UNITED STATES PATENT AND TRADEMARK OFFICE

APPLICATION NO.	FILING DATE	FIRST NAMED INVENTOR	ATTORNEY DOCKET NO.	CONFIRMATION NO.
10/728,022	12/03/2003	Gopal K. Chopra	03-389 (US01)	8331
41696	7590	12/04/2006	EXAMINER	
VISTA IP LAW GROUP LLP 12930 Saratoga Avenue Suite D-2 Saratoga, CA 95070			SOLANKI, PARIKHA	
			ART UNIT	PAPER NUMBER
			3737

Office Action Summary

DETAILED ACTION

[Source: Buchholtz et al (US Patent No. 5,409,006)]

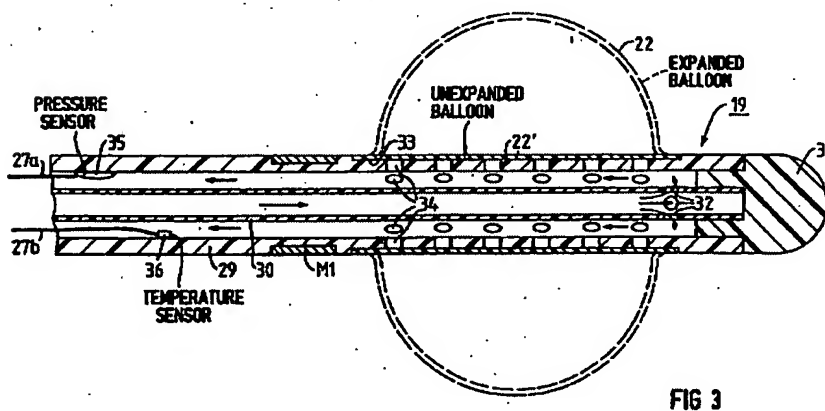
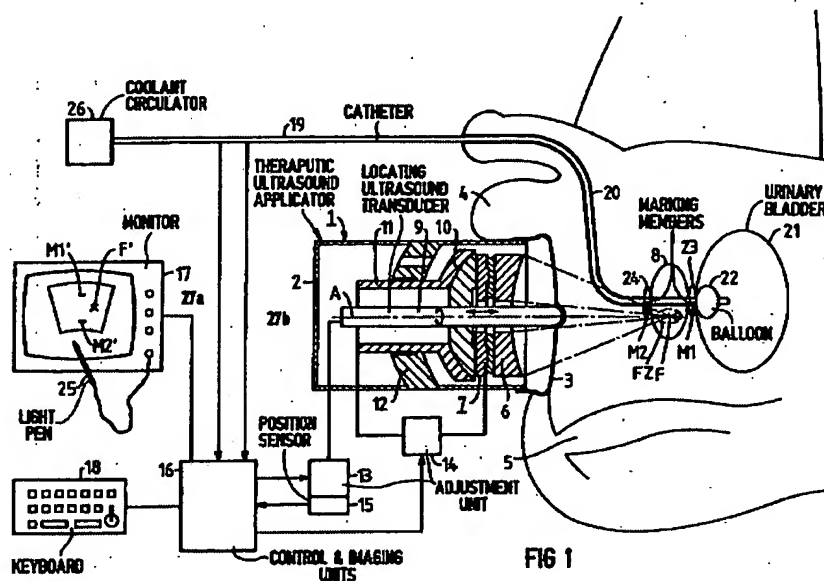
8. Claims 1-4, 7, 9-13, 21, 23 and 24 are rejected under 35 U.S.C. 102(b) as being anticipated by Buchholtz (US Patent No. 5,409,006). Buchholtz ('006) discloses a method and apparatus for delivering acoustic energy to a target site (Abstract).

The apparatus of Buchholtz ('006) includes a catheter having a distal end, a proximal end, a lumen extending there between, a channel located adjacent to the transducer, a fluid source in fluid communication with the channel, and an acoustic energy sensor secured to the

catheter distal end (col. 1 lines 56-61, col. 3 lines 27-43, col. 3 lines 61-68, col. 7 line 56 – col. 8 line 4, Figs. 1 & 3). While Buchholtz ('006) provides the embodiment for the treatment of benign prostate hyperplasia, Buchholtz ('006) states that the apparatus and method may be used to treat other maladies, and as such the acoustic energy sensor provided by Buchholtz ('006) is considered the same as a neurological signal sensor (col. 8 lines 30-32).
